MY2 FINAL MONITORING REPORT

Odell's House Mitigation Project

RE: WLS Responses to NCDEQ DMS Review Comments for Task 8 Submittal, Draft Monitoring Year 2 Report for the Odell's House Mitigation Project, DMS Full-Delivery Project ID #100041, Contract #7420, Neuse River Basin, Cataloging Unit 03020201, Johnston County, NC

The following pages present the Current Condition Plan View (CCPV).

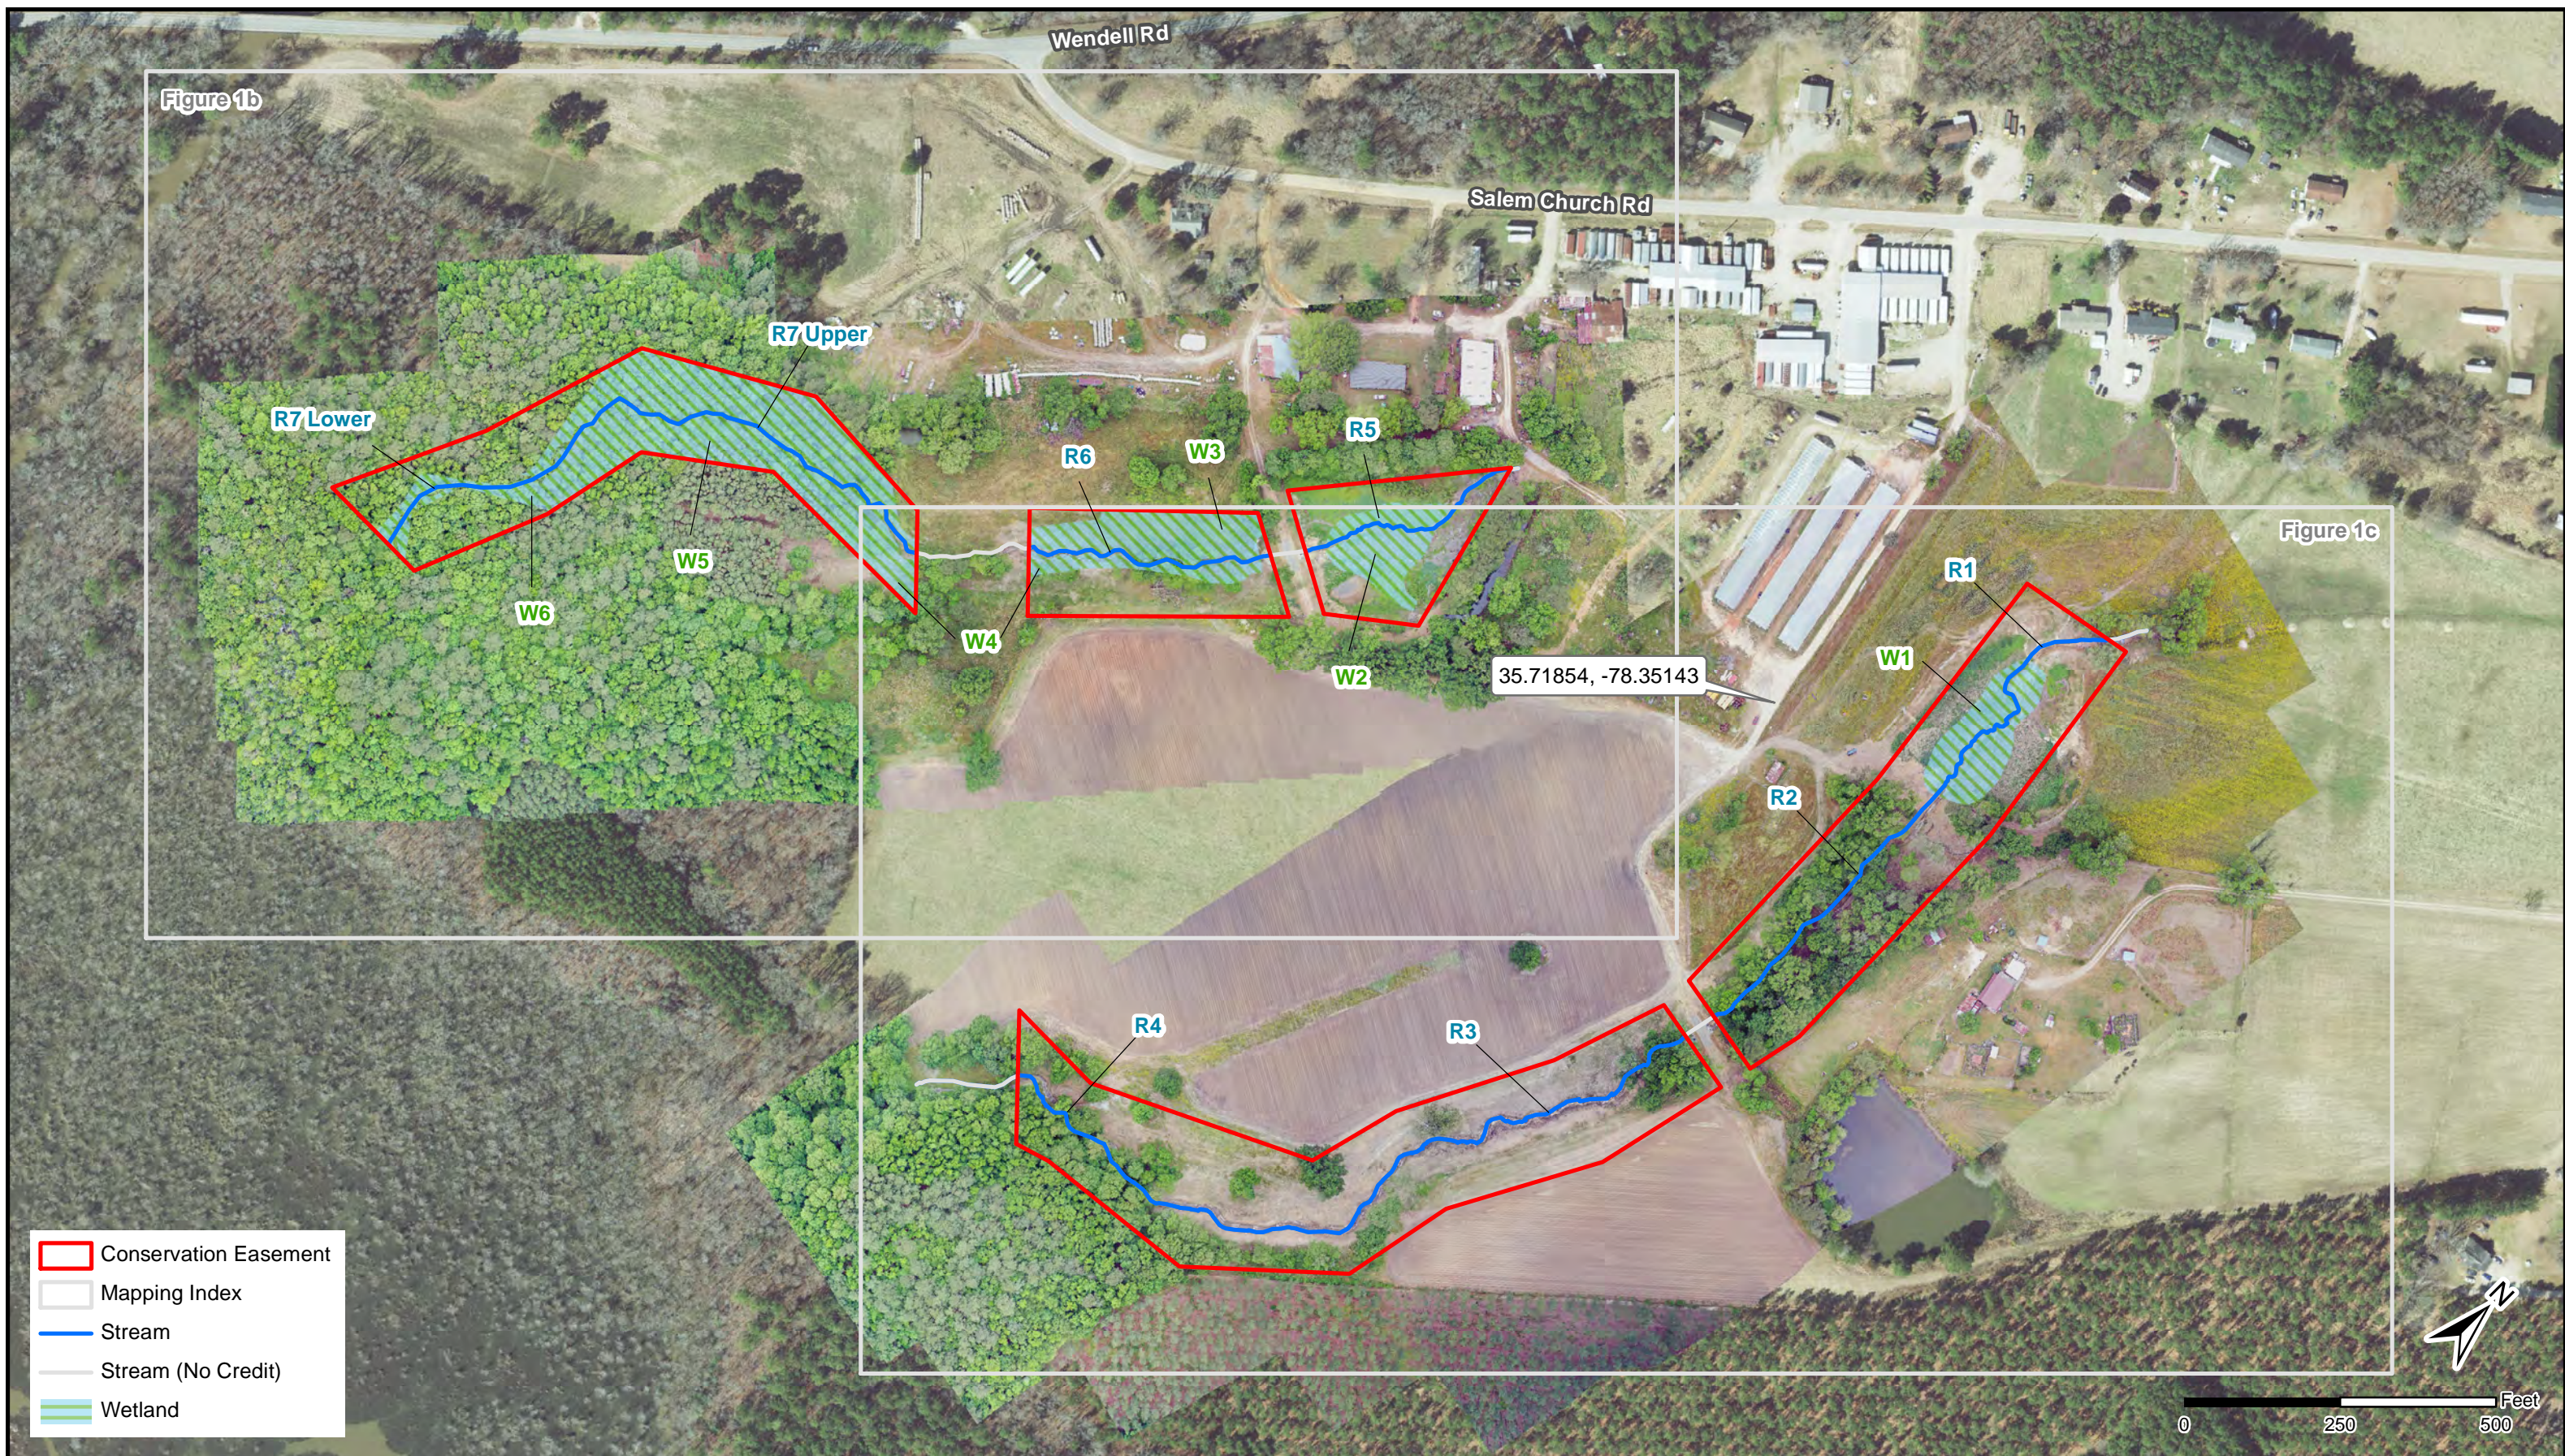
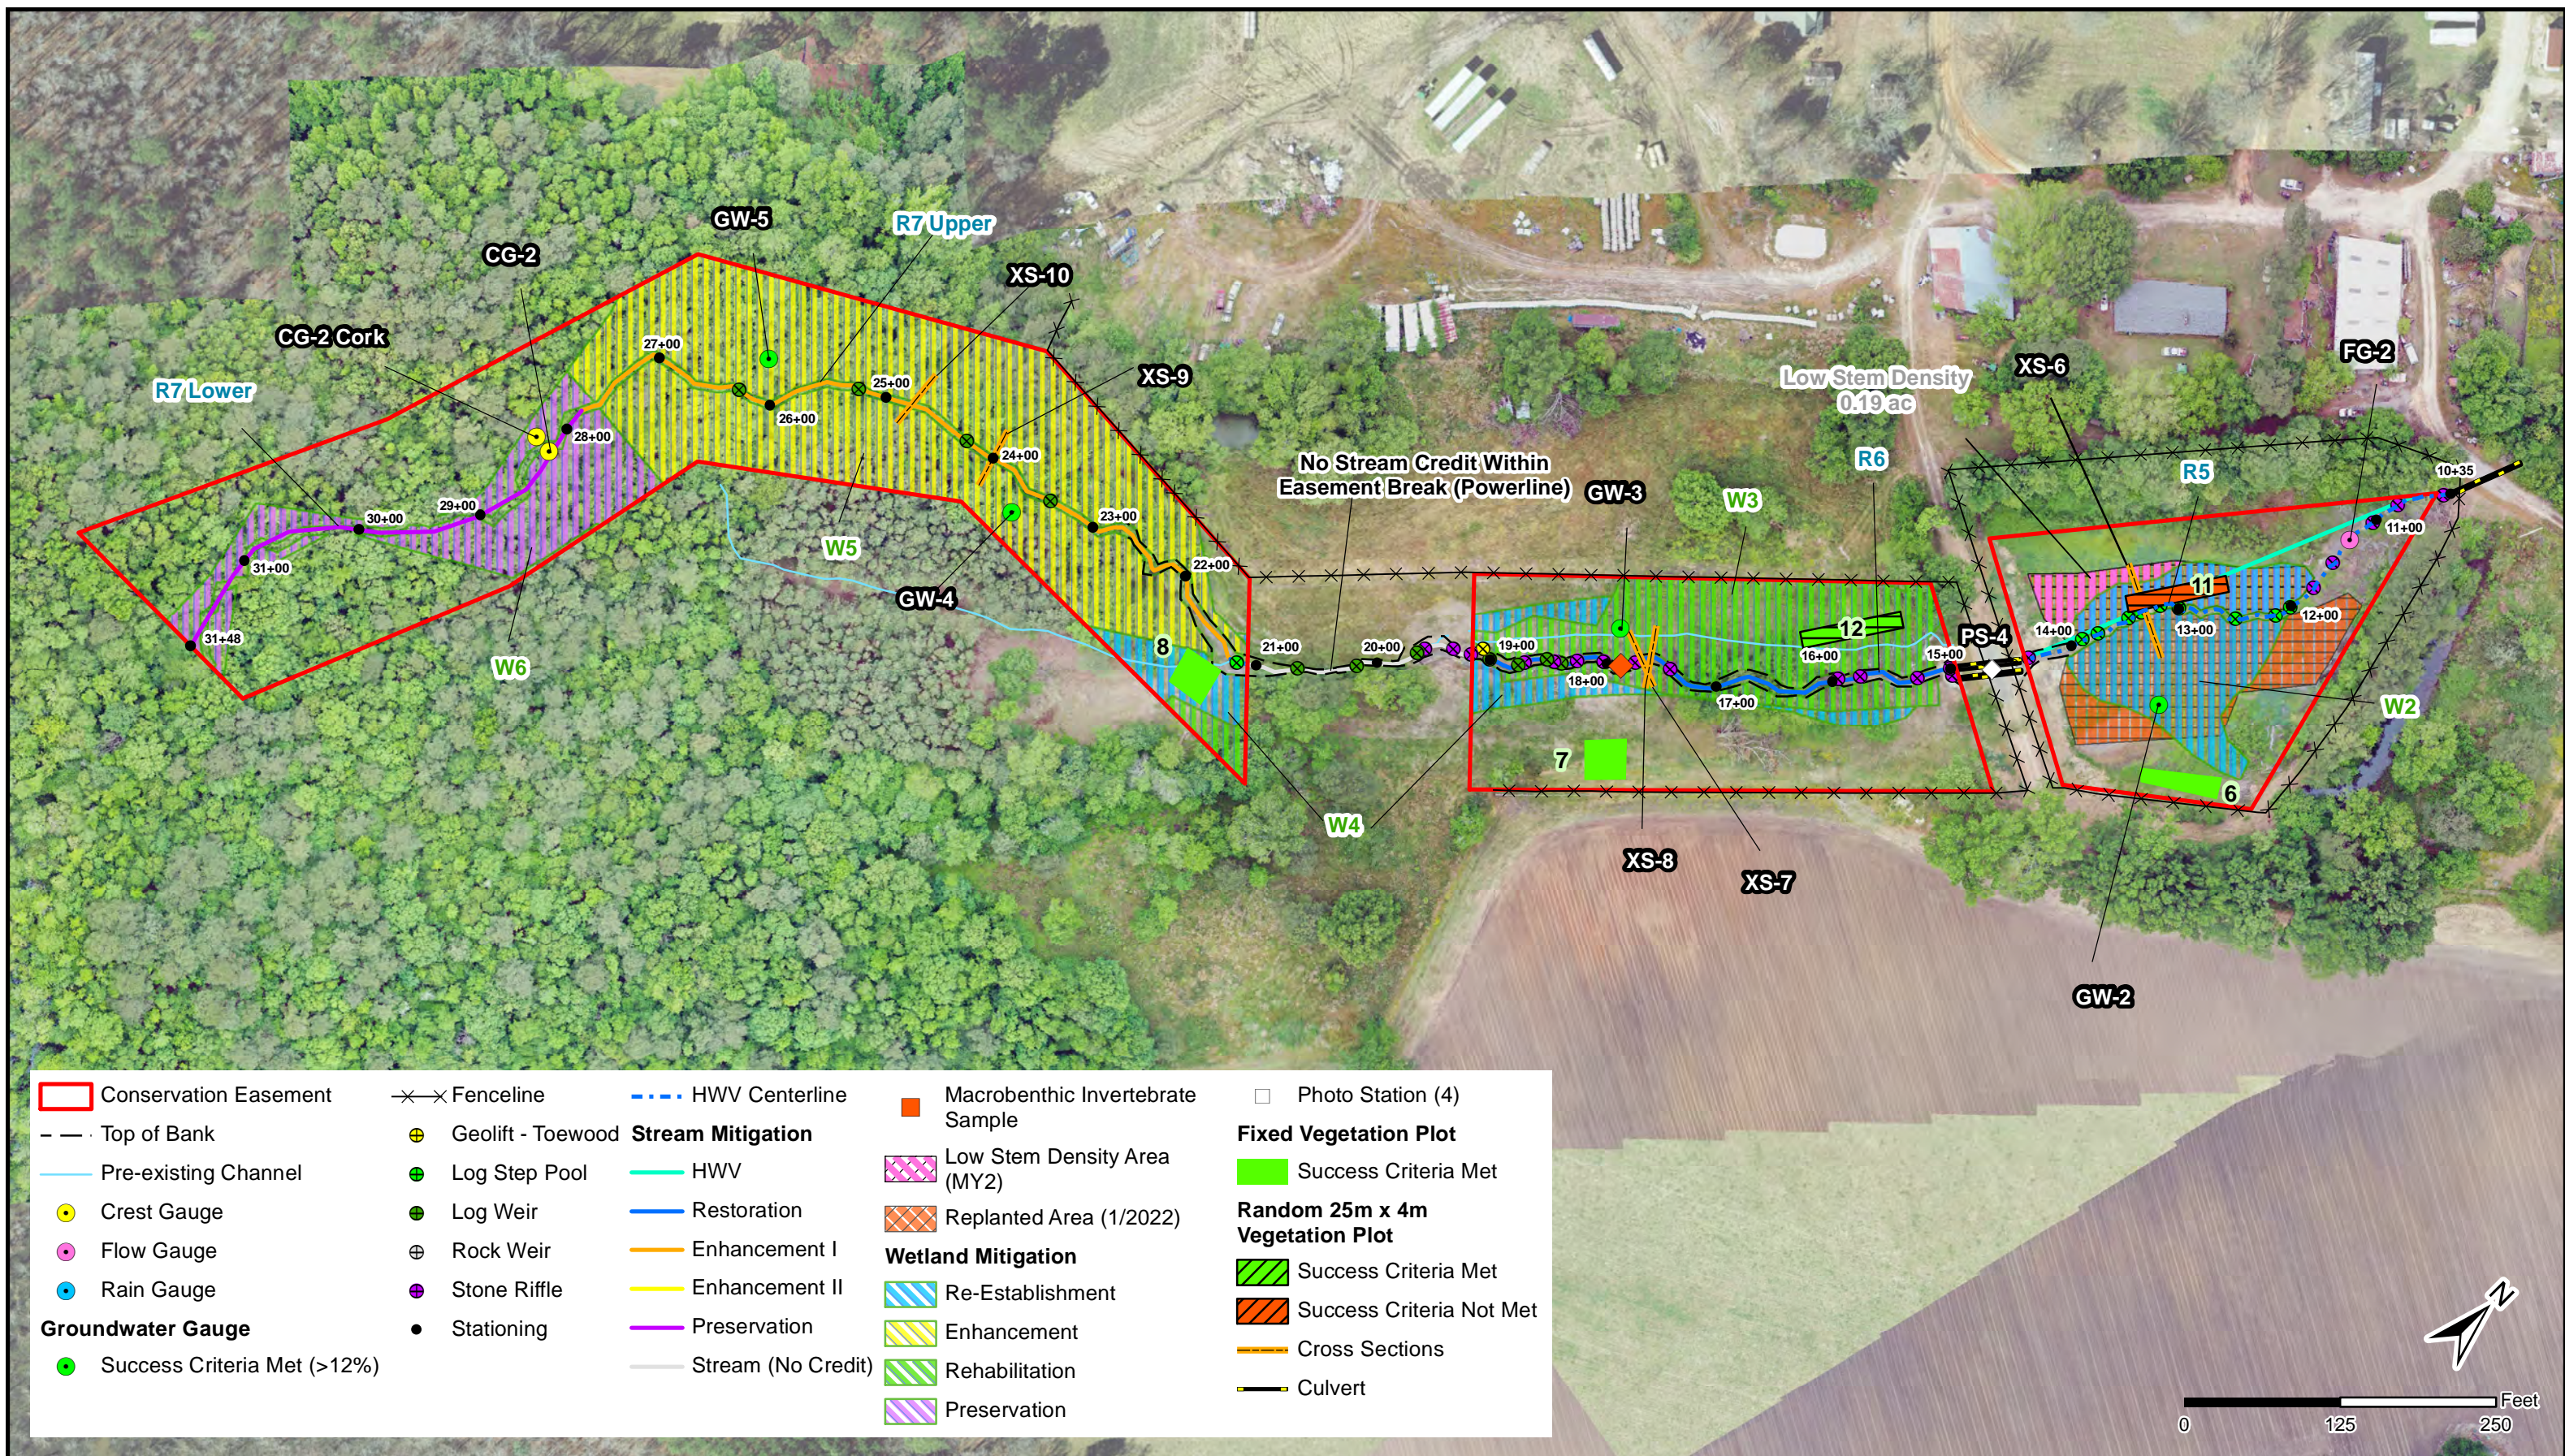
- **DMS Comment: Confirm that the 'low stem density MY2' polygon shown on the CCPV is the 1.07-acre area of replant or show replant area on CCPV.** WLS Response: The area of low stem density that was replanted was added to the CCPV. A smaller polygon (0.19 acres) within that original planted area still has a low stem density based on vegetation plot data for MY2.
